Access Compliance Report

Public Rights-of-Way

Intersection ID: 10035412	Main Street: RANDOLPH_RD	Cross Street: N/A	Location: S
ADA ID: 925E021B6981	Ramp Type: PerpDiag	Initial Pass/Fail: Fail	Overall Compliance: No
		Severity Score: 35

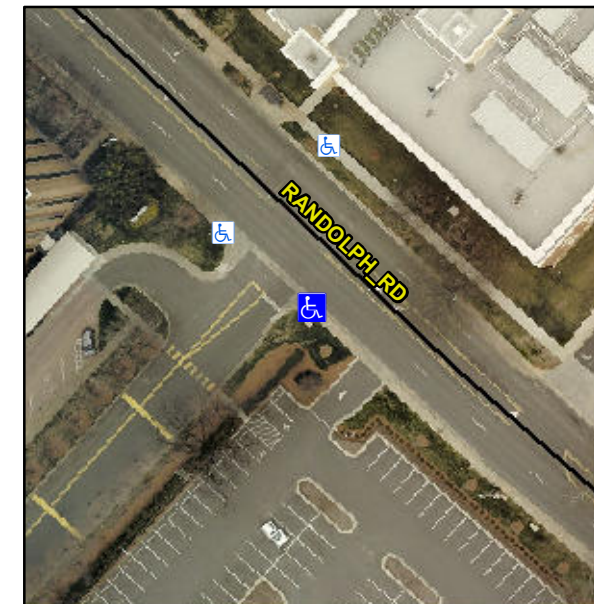
Not Found, R304.5.1, R304.2.2, R304.5.3

Compliance	Description	Data	Compliance	Description	Data
N/A	Ramp Length (in)	27.0	No	Ramp Slope (%)	14.9
No	Ramp Width (in)	41.0	No	Ramp XSlope (%)	3.0
N/A	Flare Type LT	N/A	N/A	Flare Type RT	N/A
N/A	Flare Slope LT (%)	N/A	N/A	Flare Slope RT (%)	N/A
N/A	Flare Traversable LT?	N/A	N/A	Flare Traversable RT?	N/A
N/A	Landing Length (in)	N/A	N/A	DWS Provided?	N/A
N/A	Landing Width (in)	N/A	N/A	DWS Contrast?	N/A
N/A	Landing Slope (%)	N/A	N/A	DWS Length (in)	N/A
N/A	Landing X Slope (%)	N/A	N/A	DWS Full Width?	N/A
N/A	Landing Curb? (Y/N)	N/A	N/A	DWS Offset (in)	N/A
N/A	Shared Landing?	N/A			
N/A	Gutter Ponding?	N/A	N/A	Gutter Slope (%)	N/A
N/A	Gutter Lip Ht (in)	N/A	N/A	Gutter X Slope (%)	N/A
N/A	Painted X Walk1?	No	N/A	Painted X Walk2?	No
	X Walk 1 Direction	To NE		X Walk 2 Direction	To NW
N/A	X Walk 1 Width (in)	N/A	N/A	X Walk 2 Width (in)	N/A
	X Walk 1 Slope (%)	4.0		X Walk 2 Slope (%)	2.3
	X Walk 1 X Slope (%)	4.3		X Walk 2 X Slope (%)	1.8

Remove & Replace Curb Ramp With Two New Directional Ramps or Equivalent.
